UNITED STATES PATENT AND TRADEMARK OFFICE

APPLICATION NO.	FILING DATE	FIRST NAMED INVENTOR	ATTORNEY DOCKET NO.	CONFIRMATION NO.
09/855,853	05/15/2001	Stefan J. Murry	PAT013	1173

Office Action Summary

DETAILED ACTION

**FIG. 6**

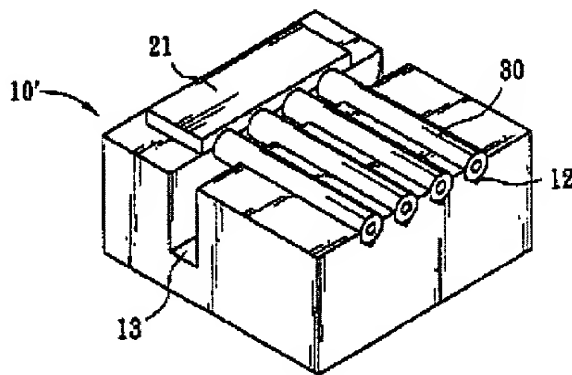
Claims 1,4,7,8,10,12,18,19,20-26,32-42 are rejected under 35 U.S.C. 102(e) as being anticipated by Wu et al (US 2002/0037137).

Figure 6 illustrates an array of vertical cavity surface emitting lasers (21) mounted on a slot (11) (not shown see figure 2) and an array of optical fibers (30), where the lasers and the fibers are all mounted on a silicon substrate. The lasers emit a light, which is optically coupled to the edge of the fiber.

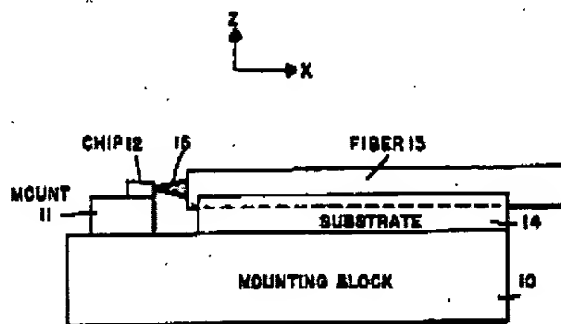
Claims 2,3,5,6,9 are rejected under 35 U.S.C. 103(a) as being unpatentable over Wu et al (US 2002/0037137) in view of Evans et al (PN 2002/003205) and Melman (PN 5,163,113).

In figure 6 Wu et al illustrates an array of vertical cavity surface emitting lasers (21) mounted on a slot (11) (not shown see figure 2 and an array of optical fibers (30), where the lasers and the fibers are all mounted on a silicon substrate. The lasers emit a light, which is optically coupled to the edge of the fiber.

Wu et al does not disclose direct coupling of the lasers and the optical devices.

In figures 2a and 3 Evans et al illustrates direct coupling of an array of lasers with an optical waveguide as separate devices and in figure illustrates the lasers and the waveguide as an integrated device.

Furthermore, direct coupling of a laser with an optical fiber is well known in the art as shown in figure 1 of Melman.

Therefore, it would have been obvious to a person having ordinary skill in the art to provide direct coupling of a laser and an optical element mounted on a common substrate because such teaches of coupling and common substrates have been well documented within the art *as taught or suggested by Evans and Melman.*

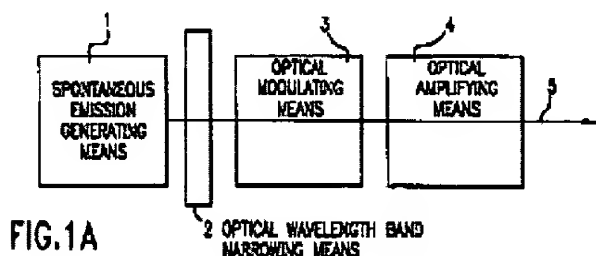
Claims 13-17,28-31 and 43-47 are rejected under 35 U.S.C. 103(a) as being unpatentable over Wu et al (US 2002/0037137) in view of Ota et al (PN 5,986,790) and McCaul et al (PN 5,625,189).

In figure 6 Wu et al illustrates an array of vertical cavity surface emitting lasers (21) mounted on a slot (11) (not shown see figure 2 and an array of optical fibers (30),

where the lasers and the fibers are all mounted on a silicon substrate. The lasers emit a light, which is optically coupled to the edge of the fiber.

Wu et al does not disclose coupling modulators, amplifiers and SOA with the array of lasers.

Coupling of optical modulators, optical amplifiers or any other optical element within a laser system is well known in the laser art and would be within the level of skill of any person having ordinary skill in the art, which understands the scientific and engineering principles applicable to the claimed invention, as shown in figure 1A of Ota et al.
